State of Ohio Environmental Protection Agency

July 7, 2010

RE: SUMMIT COUNTY
SPRINGFIELD LAKE OUTLET BASIN
CITY OF AKRON
HYRE COMMUNITY LEARNING CENTER

Figure 1. Improper inlet protection has been installed and damaged.

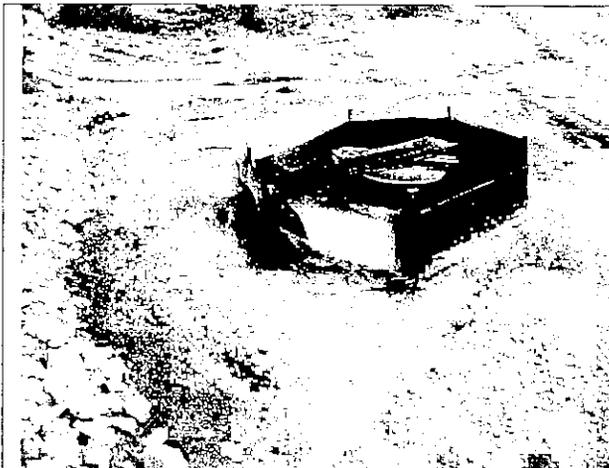
- Improper inlet protection has been installed around the site's storm sewer inlets (Figures 1 and 2). Much of the inlet protection has been damaged. Heavy sediment deposition was observed around the storm sewer inlets. Remove existing inlet protection and reinstall in accordance with the site's storm water pollution prevention plan (SWP3).
